Harnett County Department of Public Health Improvement Permit

Harnett County Department of Public Health Site Sketch

Property Location: 556 JOSEPH ALEXANDER DR. (BALLARD RD. - 521437)

Issued To: CUMBERLAND HOMES Subdivision BALLARD WOODS Lot # 124

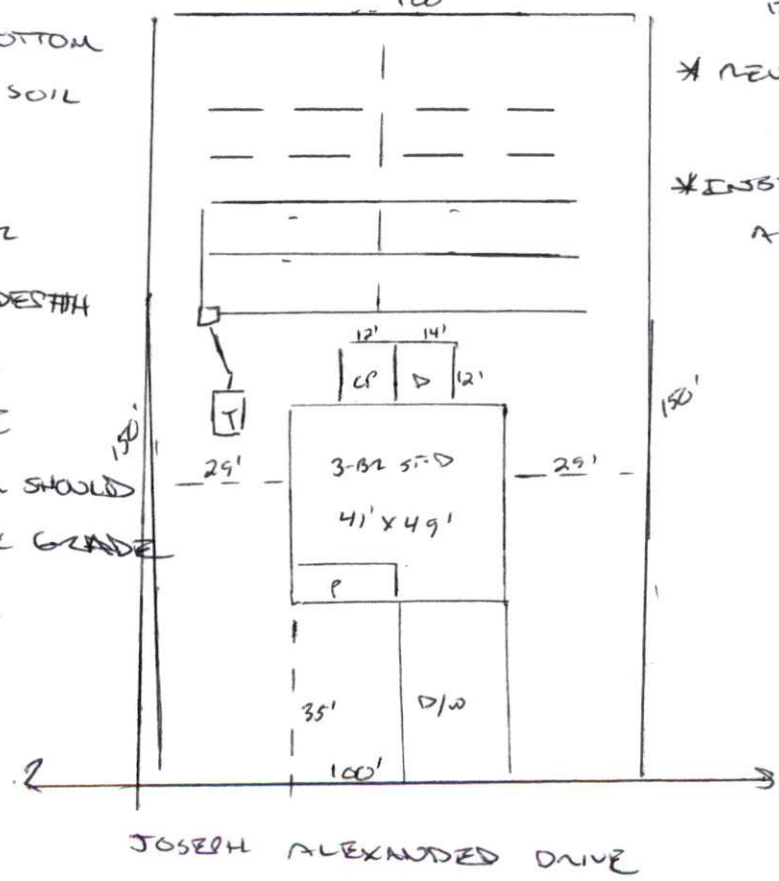
* PER ONSITE MEETING w/ APPLICANTS SOIL SCIENTIST
MIKE EAKER [SOUTHEASTERN SOIL] AND HARNETT COUNTY
E.H. SUPERVISOR [OLIVER TOLKSTORF] EXISTING IMPORTED
FILL IS APPROXIMATE GRANTED 36IN MAX TRENCH
100'

DEPTH DITCH BOTTOM
IS IN NATURAL SOIL

* REVIEW ONSITE
PRE-INSTALL FOR
FINAL TRENCH DEPTH

↳ WILL DEPEND ON
FINAL GRADE

↳ TRENCH BOTTOM SHOULD
SIT IN NATURAL GRADE

↳ PRE-CONSULT

* CAVITY TO D-BOX
EQUAL DISTRIBUTION

* REVIEW ONSITE
PRE-INSTALL

* INSTALL AS HIGH UPHILL
AS CONTOUR ALLOWS
